12-E-21-HZ
APPLICATION FOR CERTIFICATE OF APPROPRIATENESS

32 Market Square 37902
 Market Square H

Staff Report

File Number: 12-E-21-HZ

Elevations
Scale 1/8" = 1'-0"

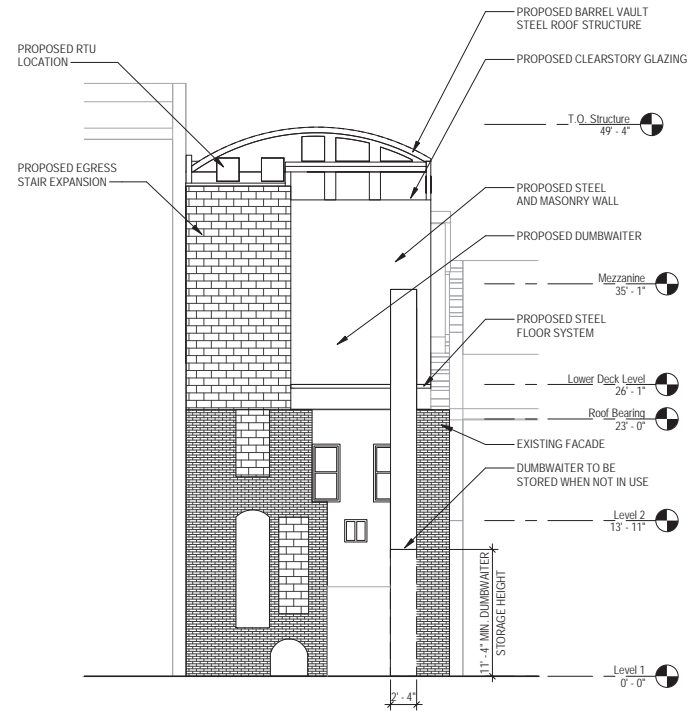
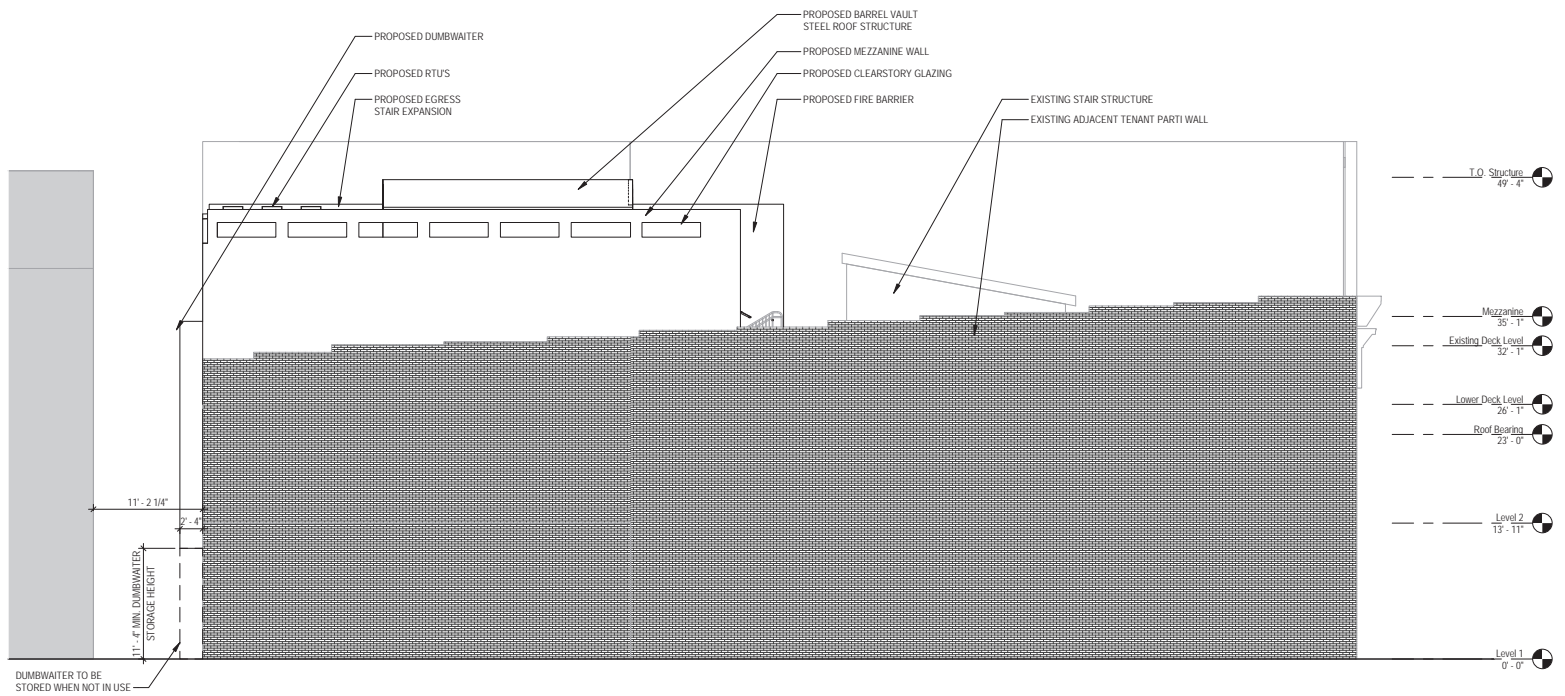
6. The barrel-vault design of the rooftop structure could be connected to the segmental arched windows on the building's façade. The rooftop structure is open to the façade, assisting in the overall transparency of the addition. The windows/openings in the barrel vault roof structure are unevenly spaced and may require revision to create even proportions more compatible with the building's symmetrical façade.

7. The use of masonry-clad walls and a steel roof structure are compatible with the existing building, as only small amounts of material will present from a full-on façade view (as shown in the elevation drawings).

Staff recommends approval of Certificate 12-E-21-HZ, subject to the following conditions: 1) revision of window/opening design on barrel vault roof structure to create more symmetry, to be submitted to staff; 2) revision (or removal of) dumbwaiter element on rear elevation to meet City zoning and building code requirements, to be resubmitted to staff or Commission for approval.

Sight Line Diagram

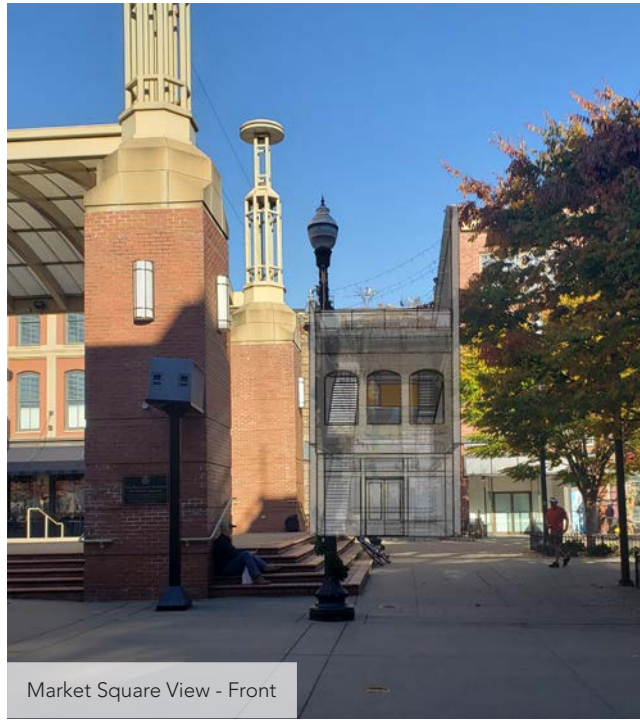
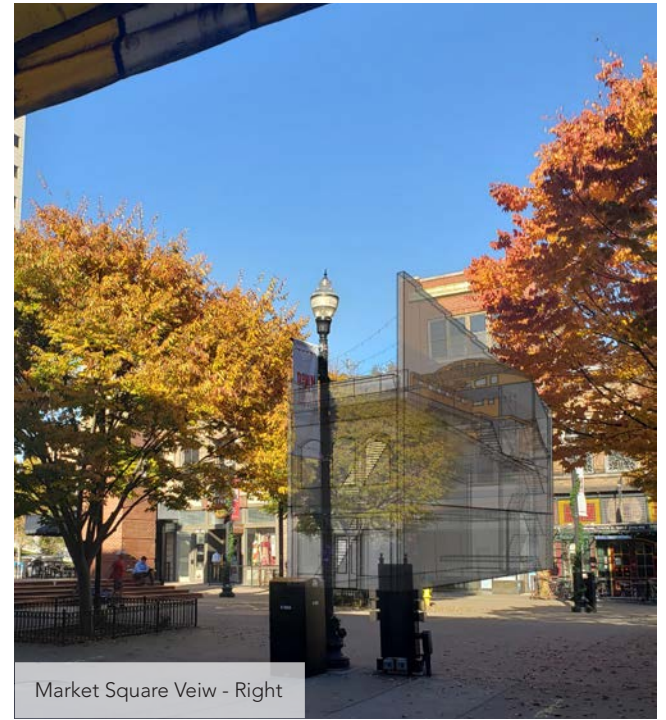
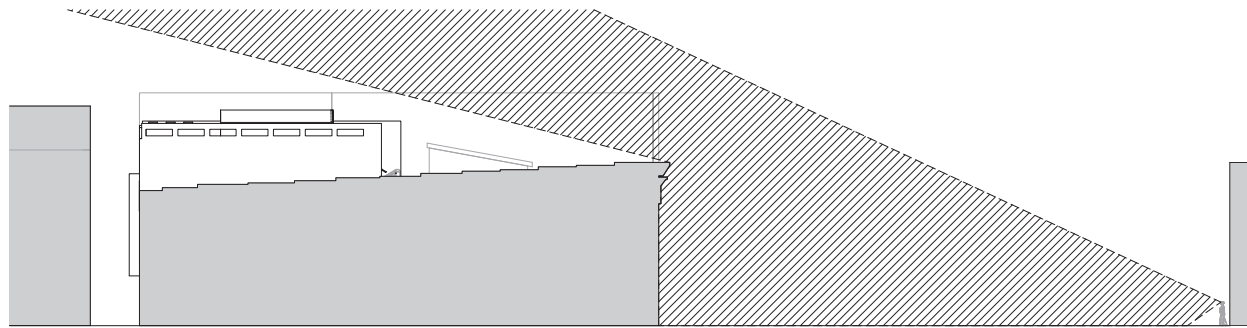
5. The applicant has provided 3-D renderings and a line-of-sight drawing, standing from points at the opposite side of Market Square, to prove the new walls and barrel vault roof structure will not be visible from the public right-of-way. Due to recessed design of the addition, the existing parapet, and the taller four-story building on the right side, and drawing on the provided renderings, the addition will not be visible from the right-of-way.
